SOUTH HEYWOOD ENABLING WORKS

DRAINAGE NOTE

OUR REF. NO. 70089657/DI/R/003

DATE: DECEMBER 2024

DRAWING NO:
SOHW-WSP-PSS-ENAB-DR-D-0002

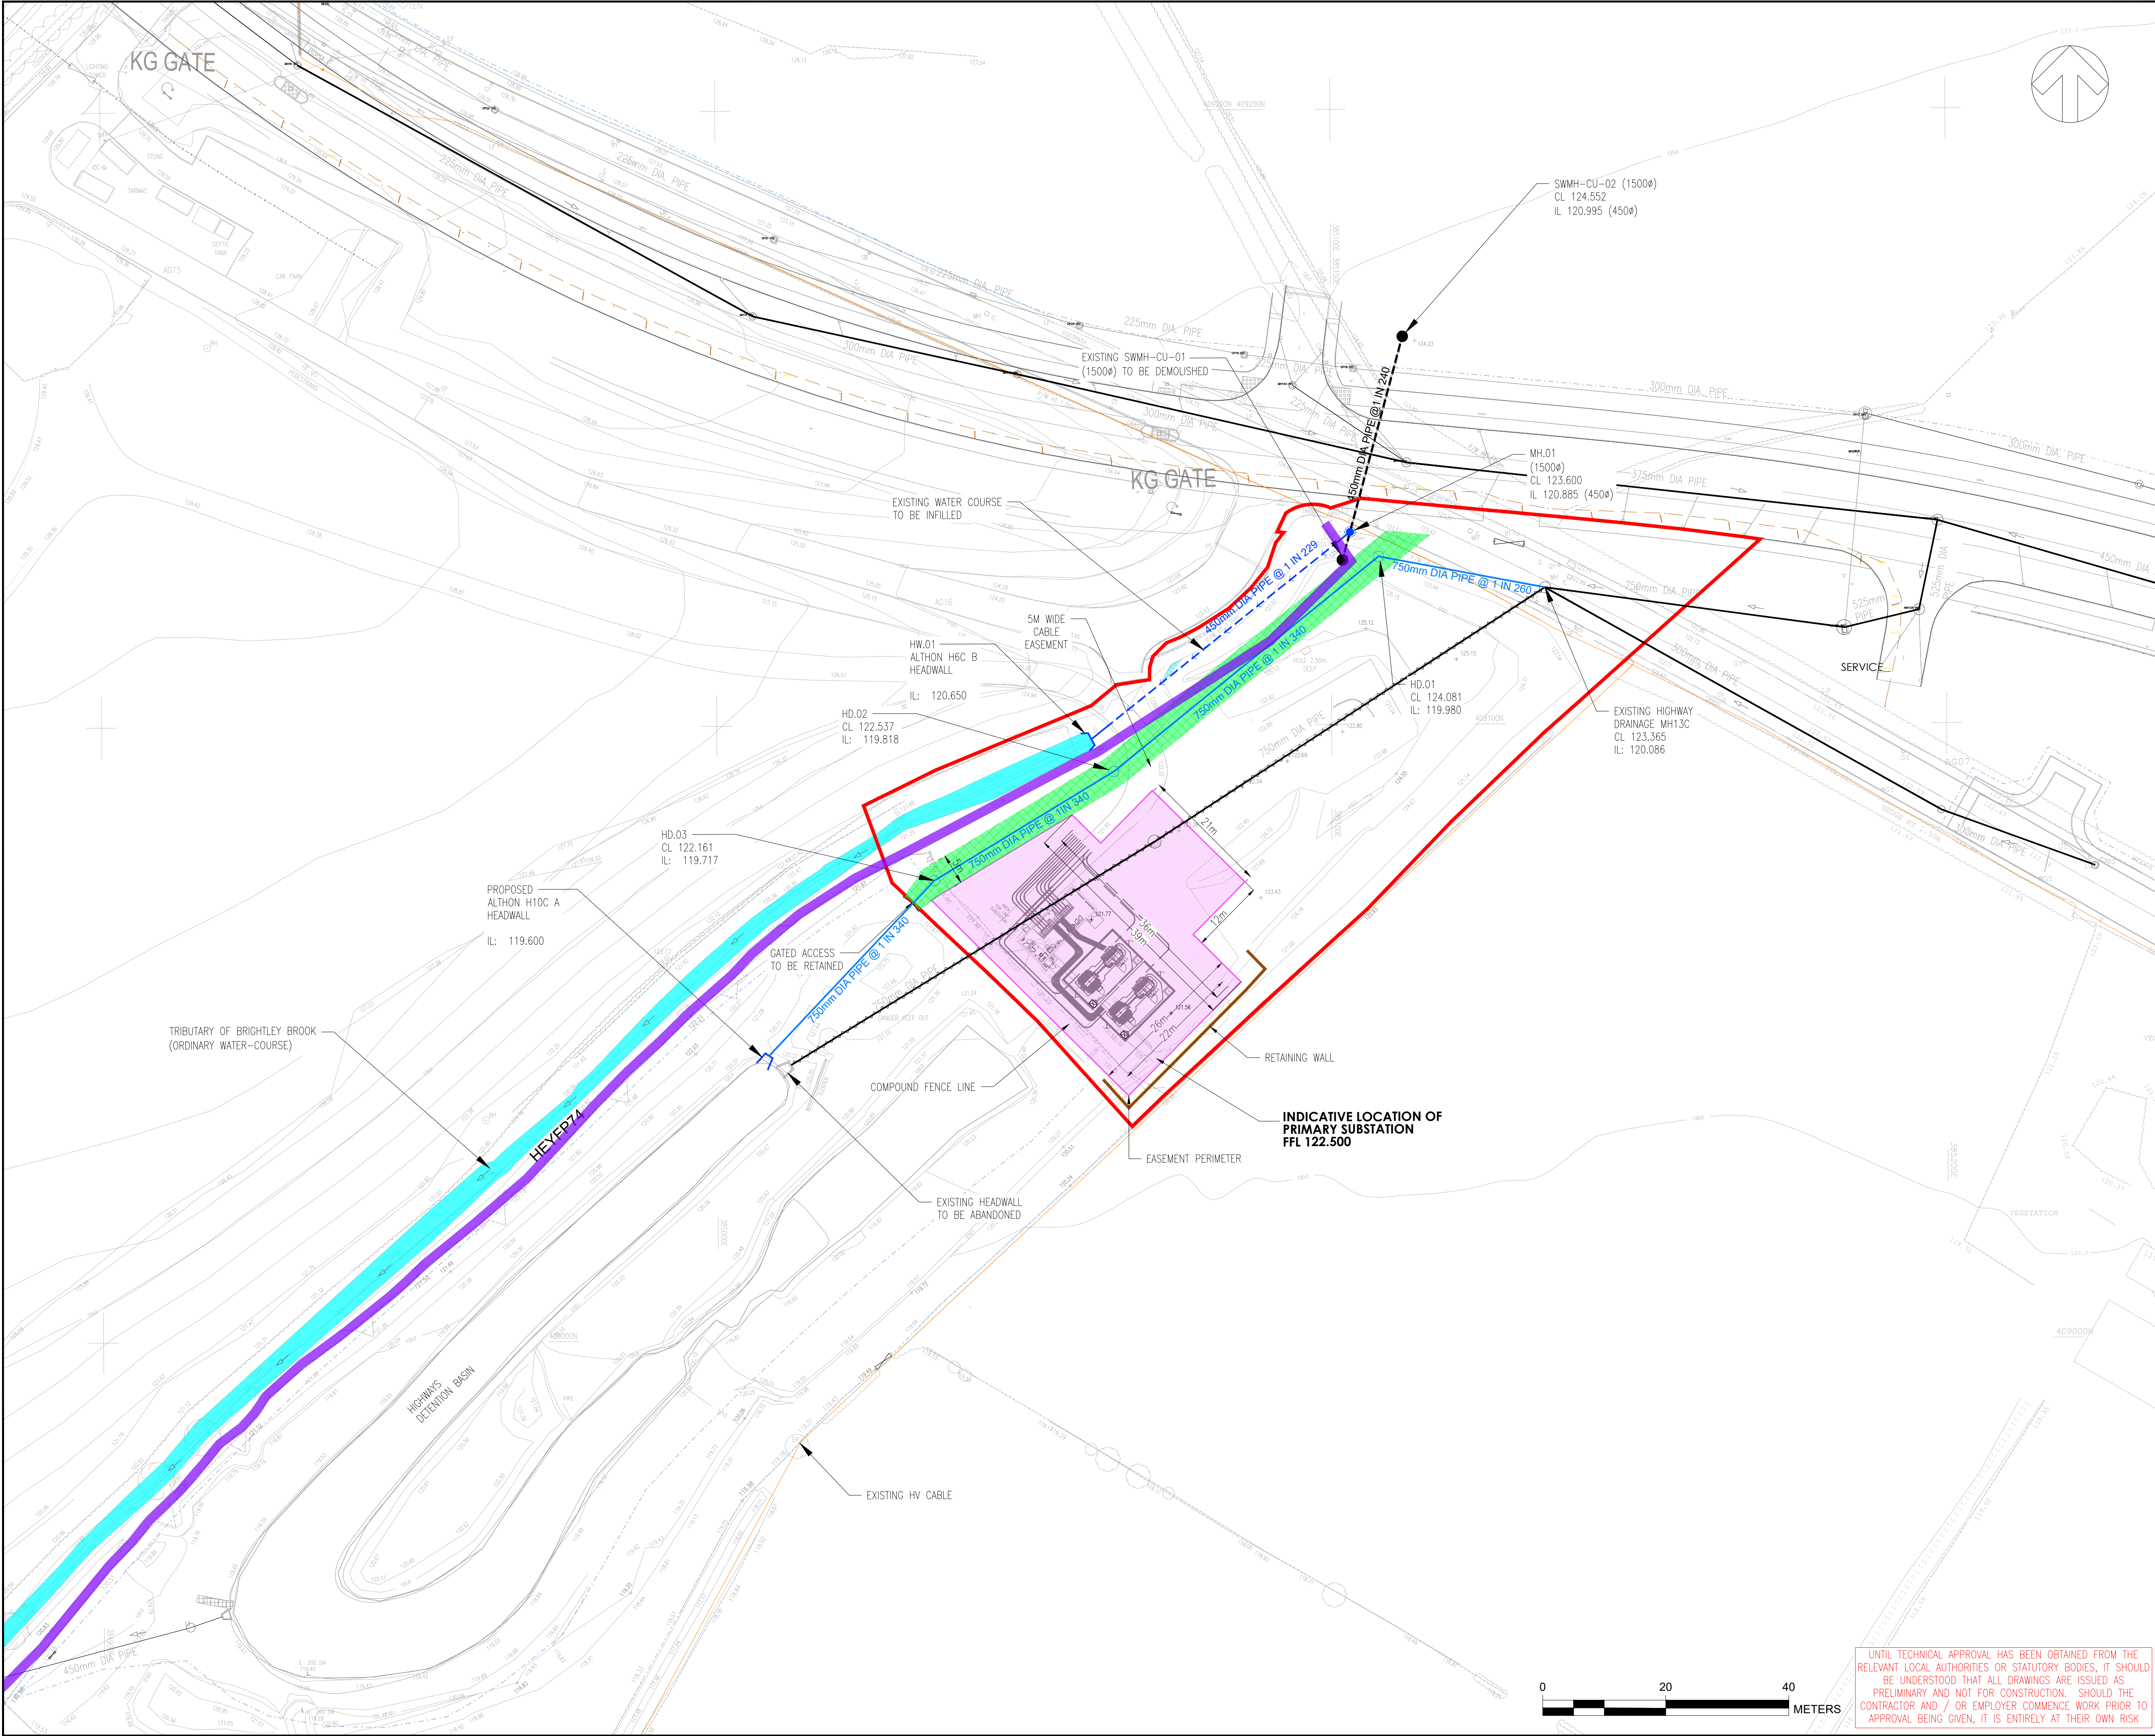
The drawing that you sent 23 Oct. is a bit better in showing your proposed highway and culvert diversions. I will go and have another look next week, Wednesday. I still don't see why you need to culvert a full 60m – see appended notes. The WSP drawing does not really clarify the access road to the sub-stn. Can that be shown?

As I mentioned before, culverts can leave problems for those who have to maintain, which is my reason for minimising approvals and minimising lengths. It is better to have a ditch before a culvert so that the drainage is not 'out of mind' and maintenance is more likely to happen. A 1:240 slope with hardly any flow will silt up until such time as a development takes place on the north side of the road and flows increase.

I went to have a look on 4th Oct. As LLFA officer, if this application of culverting some 60m of stagnant stream, I would reject it because:-

- a) There is no apparent justification for covering long lengths of stream-ditch which is currently stagnant and hardly moves. Culverting will make it worse. I append a photo of a current culvert present in this vicinity that is about 80% silted up. The existing watercourse adjacent to the district centre is currently split into two separate lengths by the existing access that will be retained as part of the development. We have reviewed our proposal such that that only the eastern section would need culverting over a length of approximately 35m. As part of the works we would replace the pipe connecting the two sections of watercourse with a 450mm diameter pipe with a formalised headwall connection into the watercourse. Based on the surveyed levels of the watercourse, we believe that a pipe can be installed at a gradient of 1:240. For a 450mm dia pipe, this equates to a full bore velocity of ~1.3m/s, which is well within the requirements for self-cleansing.

- b) If water is to come from future development on the north side of the Queen Elizabeth 2 way, more flow will come through this ditch. I couldn't actually find the inlet on the north side of the road. The Chamber cover must be grown over, if it is present. However, a ditch is far more maintainable than a buried pipe. Our understanding is that the ordinary watercourse was severed as part of the works to construct QE2 Way. The area to the north of QE2 Way therefore forms part of the natural catchment for this watercourse, hence the installation of a cross carriageway culvert to facilitate future development to the north. Whilst I accept that the chamber to the north is difficult to locate, the as-built position has been surveyed so it will be possible

- c) It is not just me; the Council has numerous issues with streams which have been culverted in the past without any thought to future maintenance. Maintenance requirements have been fully considered within the attached proposal. The proposed pipe size is significantly larger than the greenfield flows that will be permitted. This allows for sediment build up within the pipe without impeding flows. However, as noted above, self-cleansing velocities can be achieved which will minimise the risk of sediment building up within the pipe. A formal headwall will be constructed at the outfall into the ditch and manholes will be provided at changes of direction.

- d) The only justification for a short length of culvert is when an access road crosses the ditch. Generally I would agree with this sentiment. However, in this instance the length of watercourse we are proposing to culvert is located at the very top of the catchment, is of low quality, and culverting will not introduce any flood risks. Maintaining this section of watercourse has a disproportionate affect on the proposed district centre development due to the shape of the plot.

Following my site visit with you to discuss the arrangements, I have no objection to the modifications to the existing pipework on your South Hywood Primary Substation – Enable Works GA drawing SOHW-WSP-PSS-ENAB-DR-D-000/P03 dated 8 Dec 2023.

to locate in the future. Any future development to the north of QE2 Way would be designed and attenuated back to greenfield runoff rates, restoring flow through the watercourse and minimising the risk of stagnation.

We have reviewed and updated our previous proposal that significantly reduces the length of watercourse we are seeking to replace with a buried pipe. I should therefore be grateful if you would review and comment on our revised submission in advance of a formal permit application.

Thank you for the attached. As it is subject to a future planning application, no objection in principle to the proposal.
